Final Environmental Impact Report
for the
Central Lathrop Specific Plan

SCH# 2003072132

Prepared for
City of Lathrop

October 2004

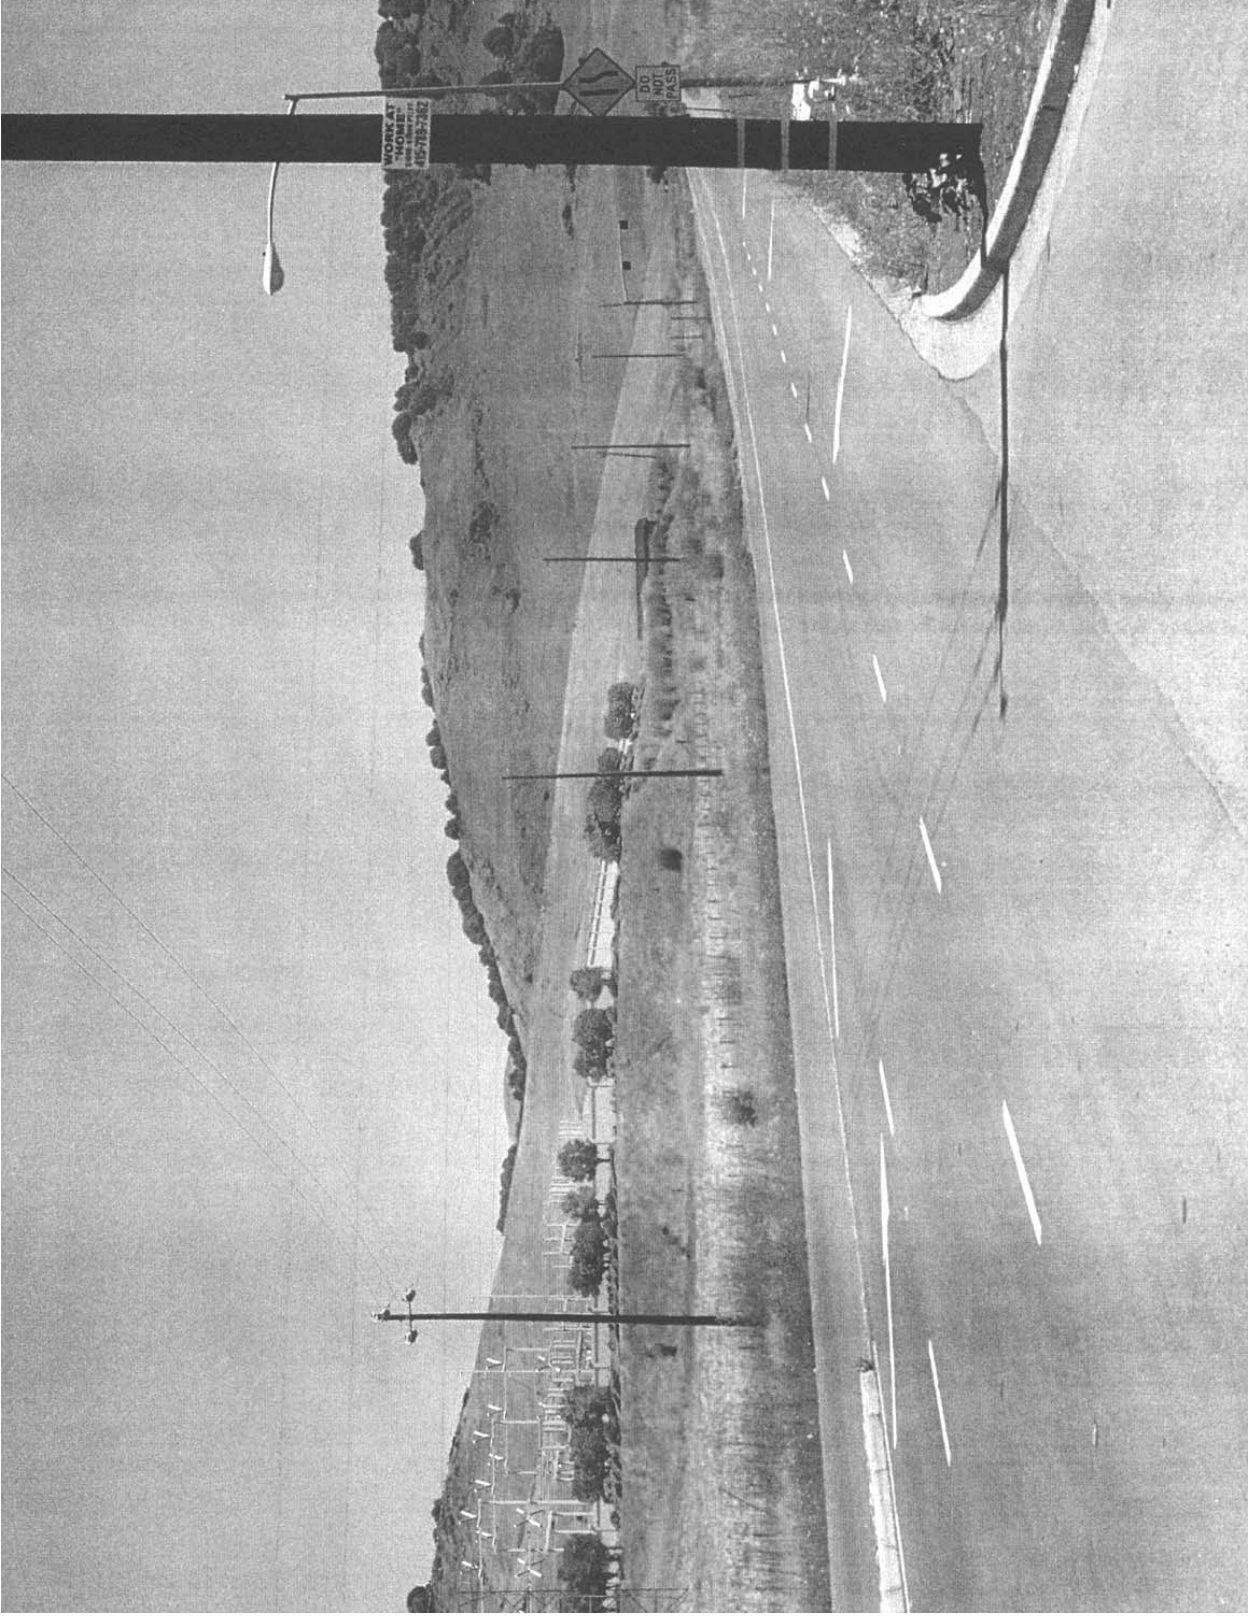
After reviewing the draft document and during discussions with the project proponents, Pacific Gas and Electric Company (PG&E) has concluded that PG&E will need to construct a new electric substation and electric transmission line loop in order to serve the development planned within the specific plan boundaries.

PG&E has determined that the most efficient location of the substation is along the westerly right of way line of Interstate 5 (I-5) just south of the alternative site of the wastewater treatment plant. The substation would be between 3 and 4 acres in size depending on the shape. I have enclosed a diagram/photograph depicting a typical substation of the type that will be required. The 115kV electric transmission line loop will cross I-5 and tie into the existing transmission line located along the easterly right of way line of I-5 and opposite of the substation. The transmission loop would be constructed on two new tubular steel poles, one on each side of I-5. I have also enclosed a diagram depicting a typical 115kV tubular steel pole.

EXHIBIT 4.4-25a
 Revised

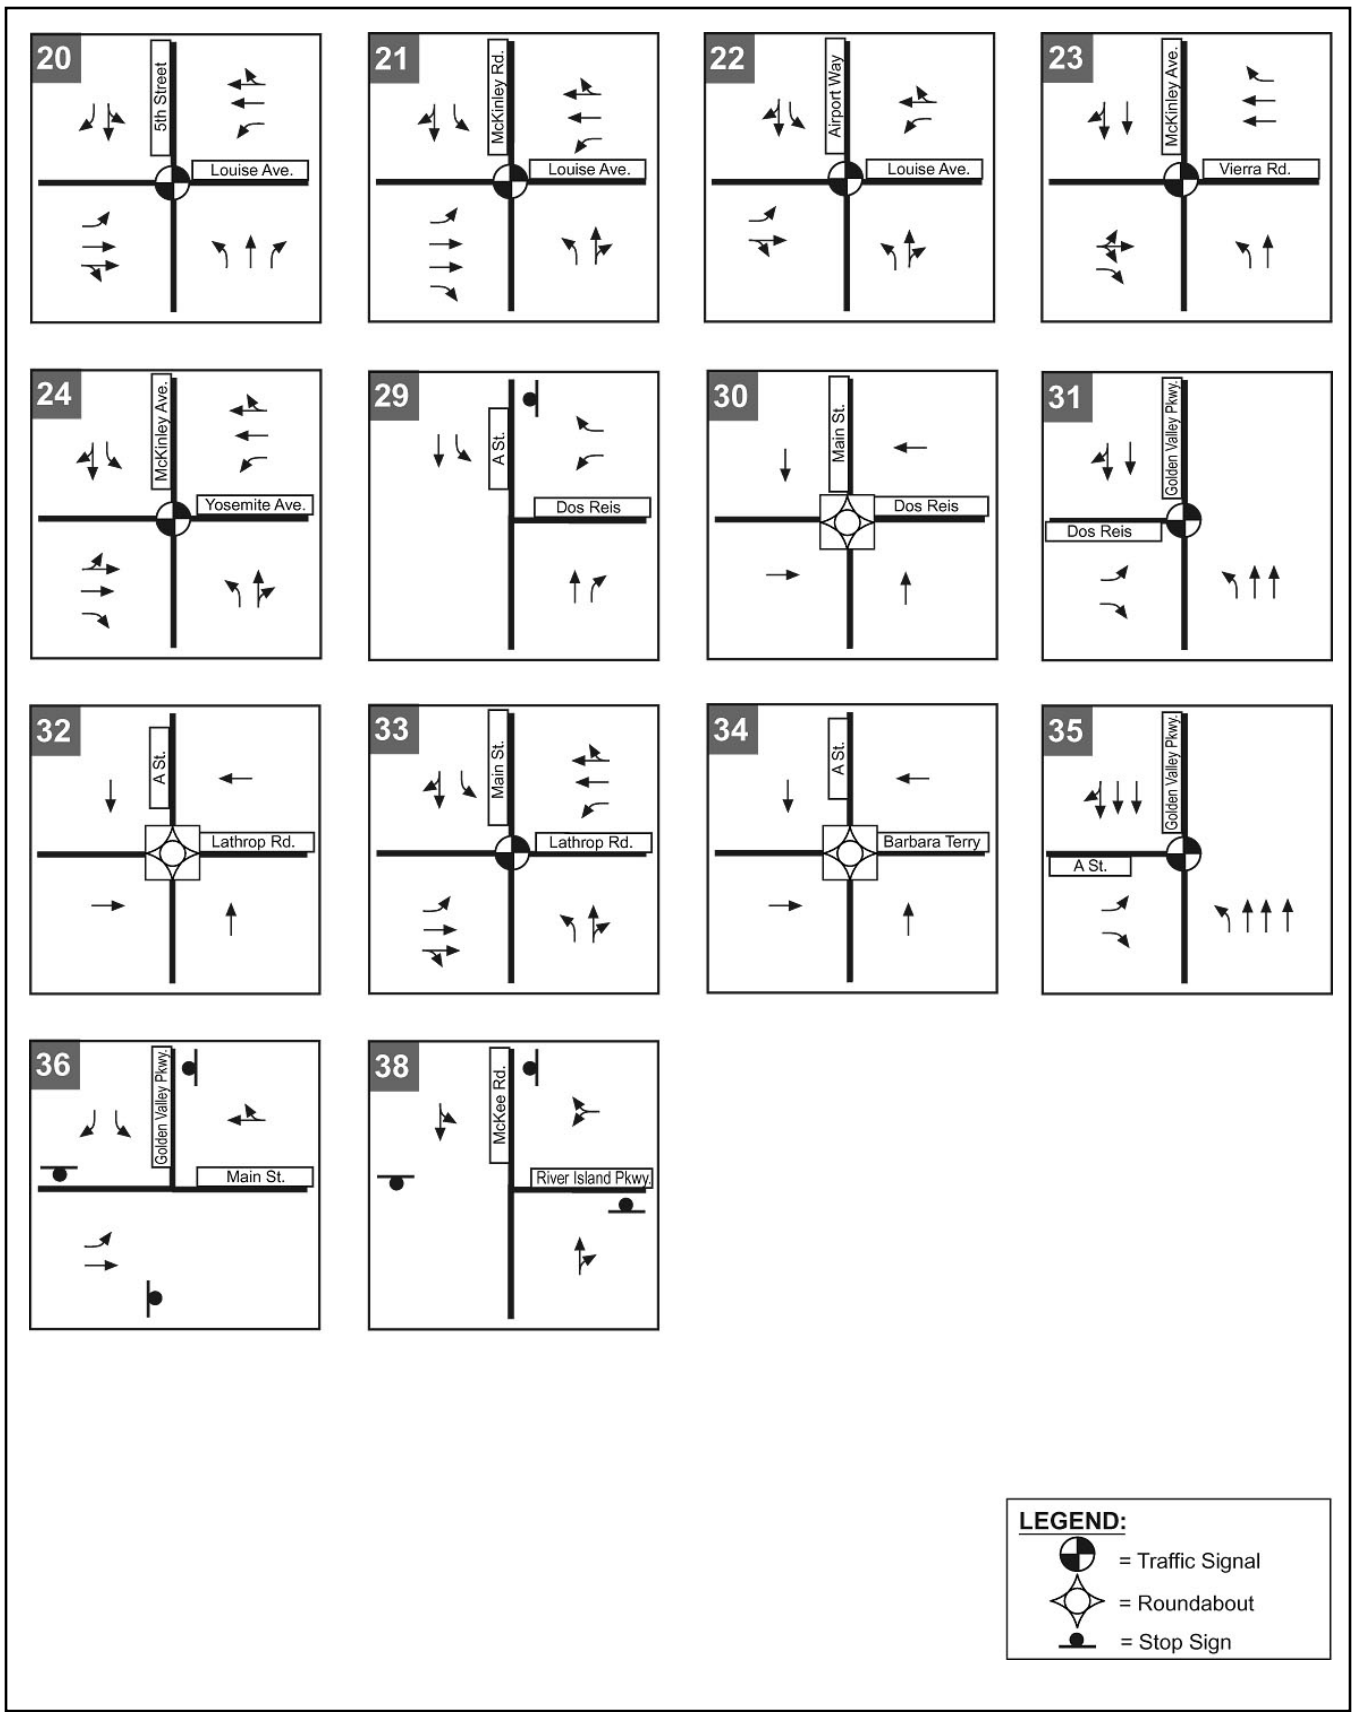
- Why do WB lanes at the Roth Road/I-5 NB intersection change from 2 thru & 1 right lanes back to 1 thru & 1 shared thru/right lanes under 2010 Plus Phase 1 before and after mitigation? There is no discussion in the text. Is this a mistake?

S1-8 The mitigation text referenced by the commenter is correct, while the corresponding graphics are incorrect. Based on a review of the exhibits included in Section 4.4, Transportation and

- S1-9 Lane configurations for the intersection referenced by the commenter are represented incorrectly in Exhibit 4.4-25a. As stated in the response to comment S1-8 above, a corrected version of the exhibit is provided in Chapter 3 of this FEIR.

EXHIBIT 4.4-25b Revised

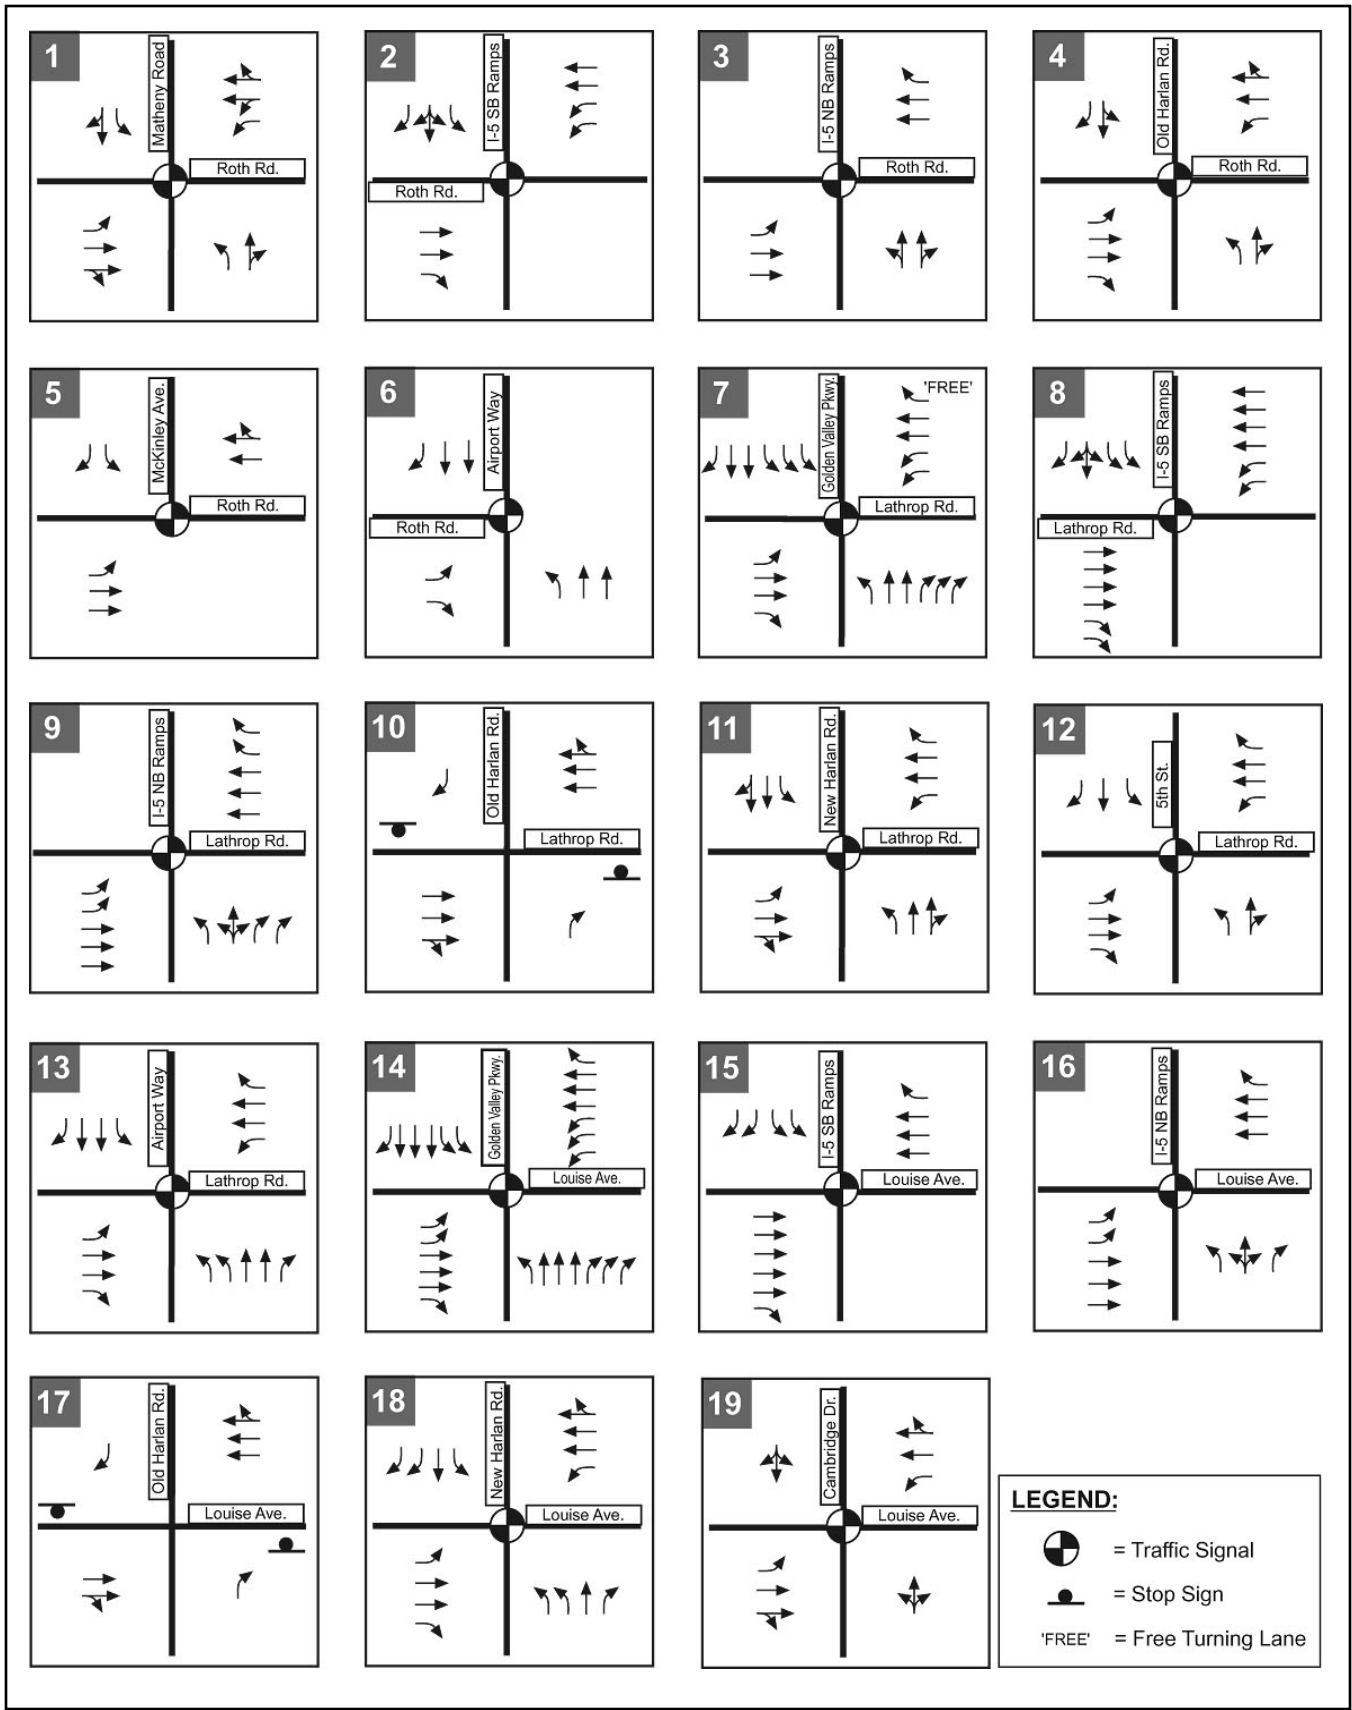
- The Louise Avenue/I-5 SB ramp intersection configuration is not correct under all figures of the 2020 scenarios (including lane configuration and volumes). They show traffic going onto the SB off ramp. It is not clear which volume is for which WB movements.

- S1-10 See response to comment SI-9.
- S1-11 The City of Lathrop, through the development of the CFF in 2003, had previously identified the need for a loop on-ramp in the northwest quadrant of the Louise Ave./I-5 interchange. Therefore, the traffic analysis in the DEIR assumed this partial cloverleaf configuration with a loop on-ramp for westbound traffic on Louise Avenue to access I-5 southbound. However, based on a review of the exhibits in Chapter 4.4, Transportation and Circulation, it was found that Intersection 15, Louise Avenue/I-5 SB Ramp was not represented correctly in Exhibit 4.4-26a. As stated in the response to comment S1-8 above, a corrected version of the exhibit is provided in Chapter 3 of this FEIR.
